# Final decision

AusNet Services electricity distribution  
determination

1 July 2026 - 30 June 2031

**Attachment 2 – Capital expenditure**

**Figure A2.1 — BN11 performance**

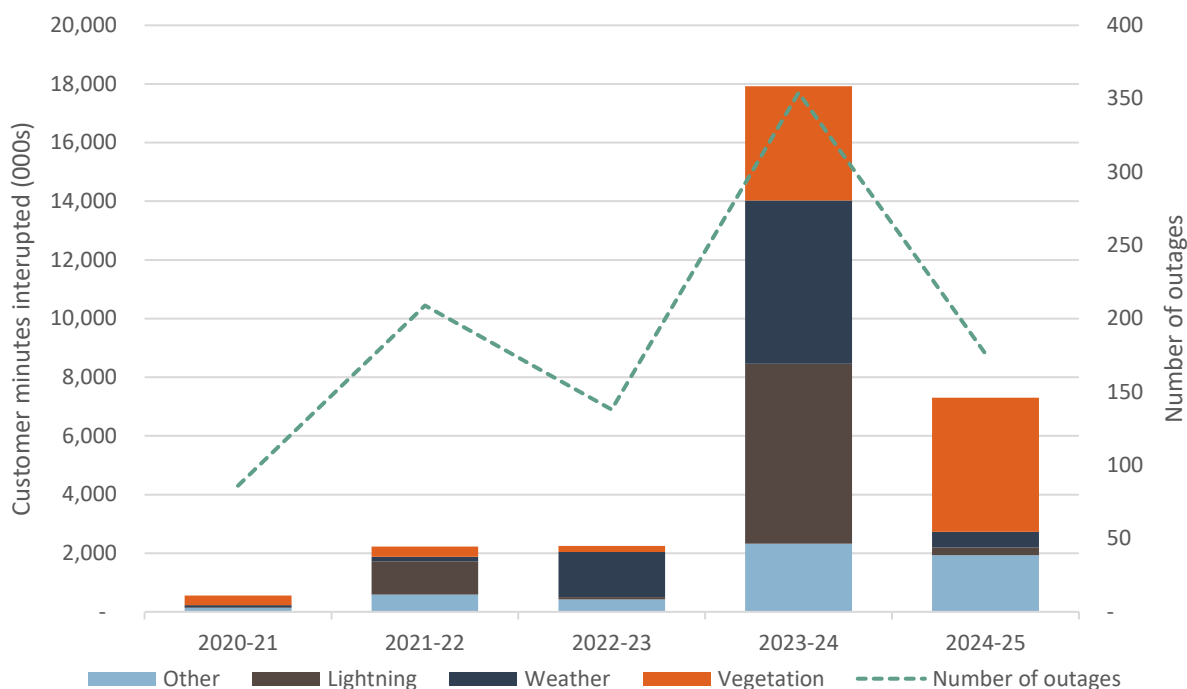
As shown below in Figure A2.1 the performance data reflects a material improvement in reliability performance in 2024–25 compared to the year prior. However, outage length in 2024–25 remains above historical levels.
